**SUPPLEMENT SHEET
TO
MODEL PA300 SERVICE MANUAL
FOR MODEL PA300*012-NY**

B. MANUAL CHANGES.

1. Page 2. Change the following paragraphs, as shown below:

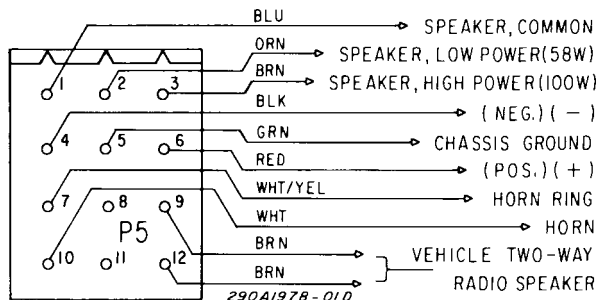
Frequency Range	800 to 1800Hz
Operating Current (14.0Vdc-WAIL)	
1 Low Power Speaker	5 amperes
2 Low Power Speakers	10 amperes
1 High Power Speaker	10 amperes
2 High Power Speakers	15 amperes
Voltage Output (approx.)	
1 Low Power Speaker	45Vp-p
2 Low Power Speakers	40Vp-p
1 High Power Speaker	64Vp-p
2 High Power Speakers	60Vp-p

Component Location Detail.

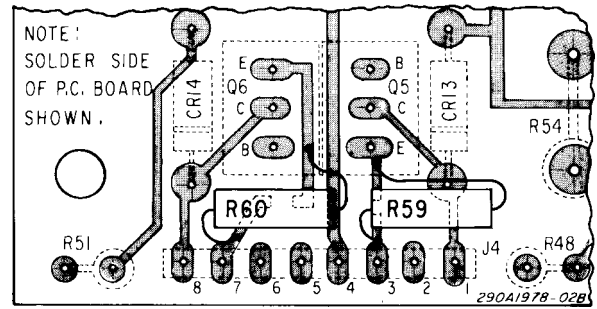
6. Page 14. Refer to the component location diagram detail in this supplement to locate the additional PA300*012-NY components (R59, R60).

a. Add:R59, 60- Resistor, 0.47 ohm, 2W, 10%. Part No. 130A130.

Model PA300*012-NY Schematic Diagram.

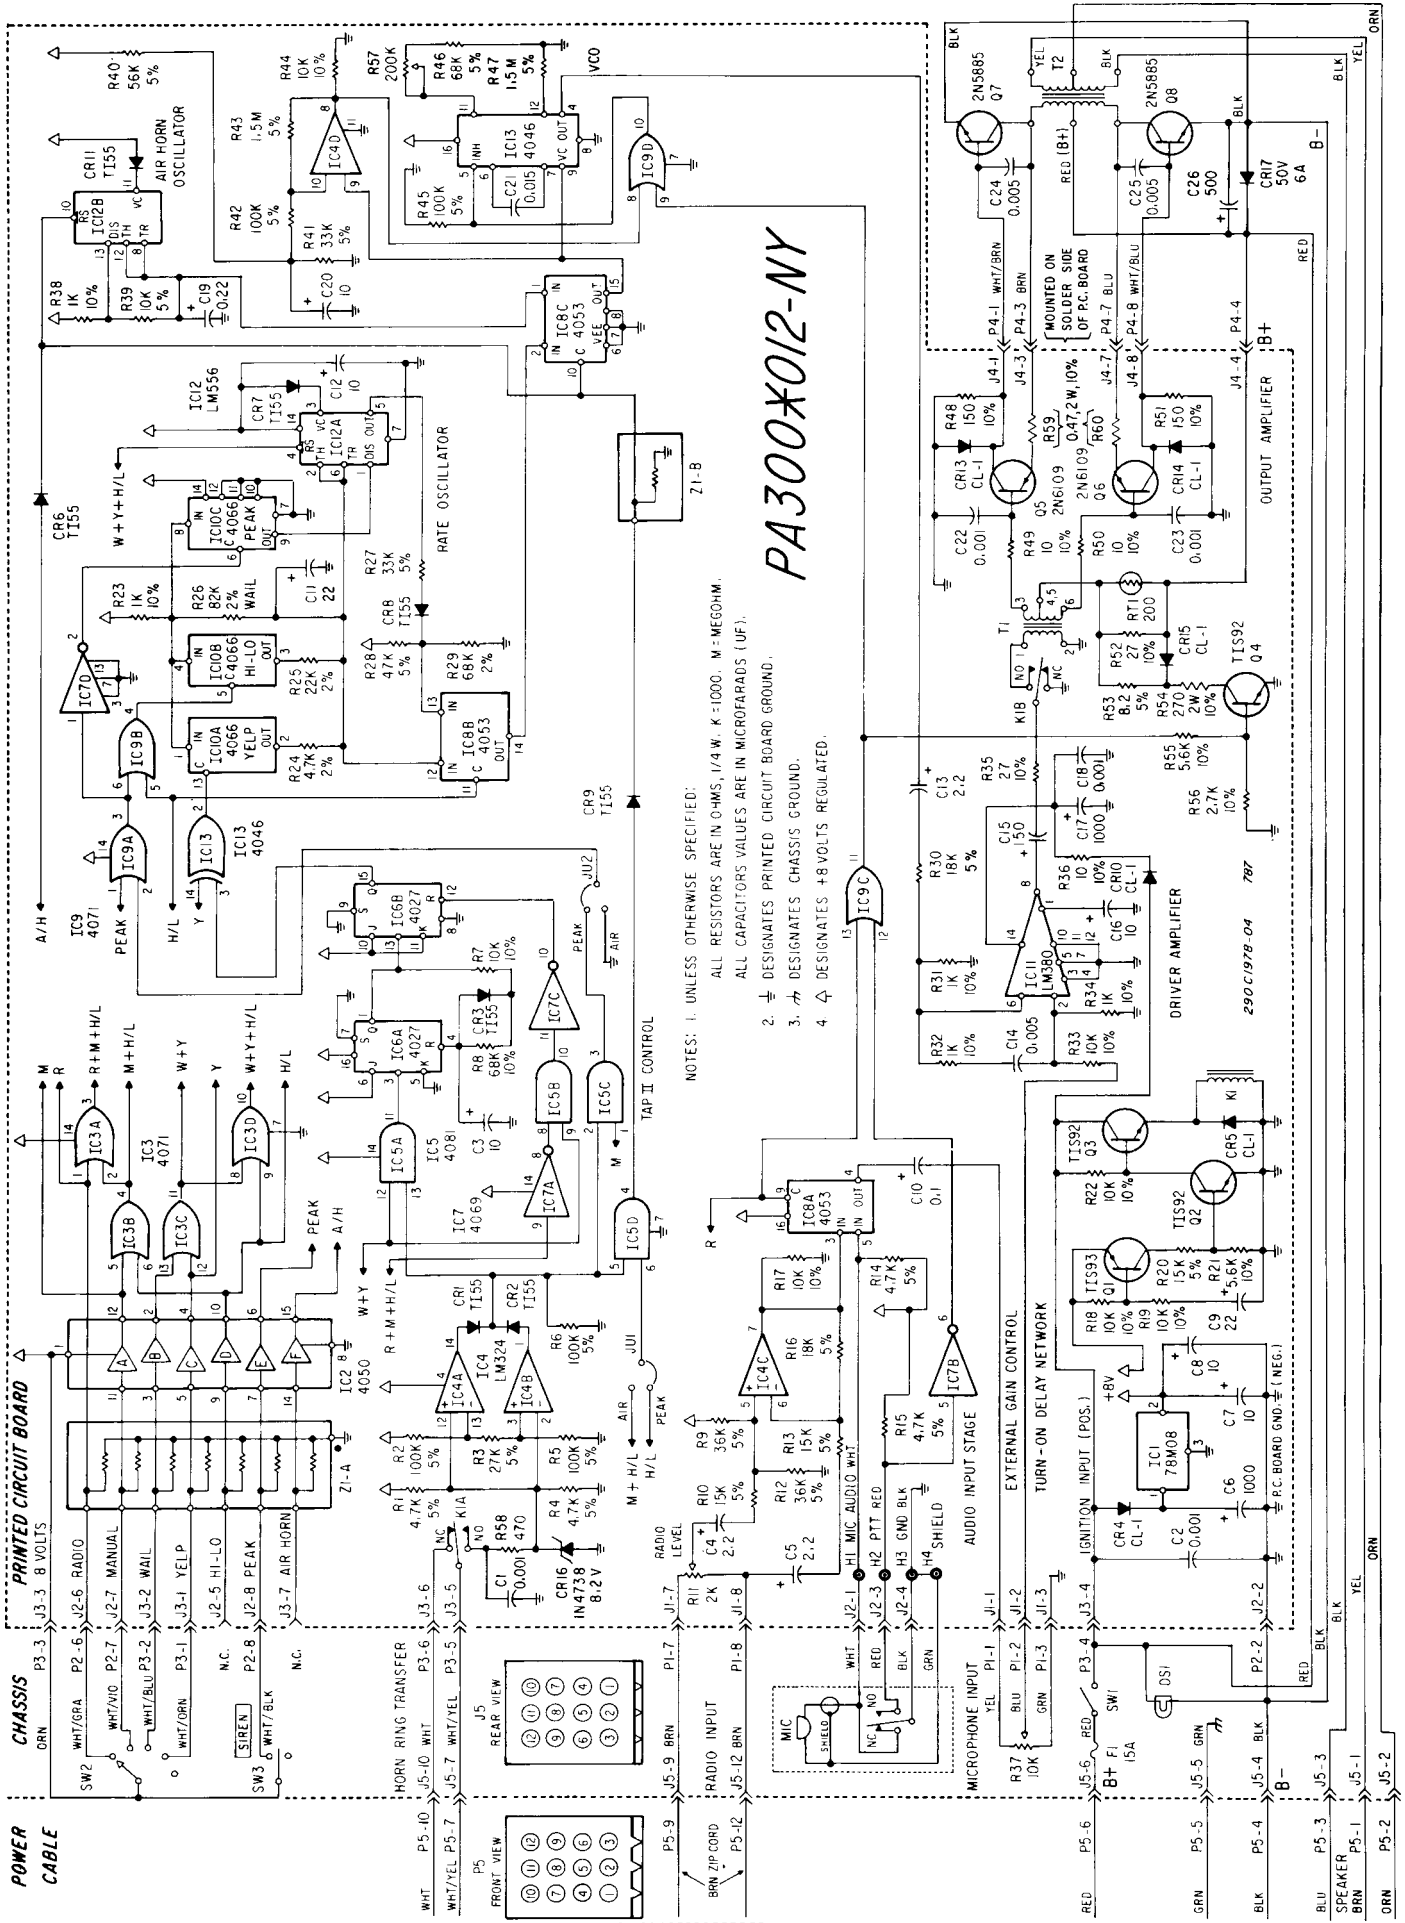
7. Page 15. A Model PA300*012-NY schematic diagram is included in this supplement sheet.
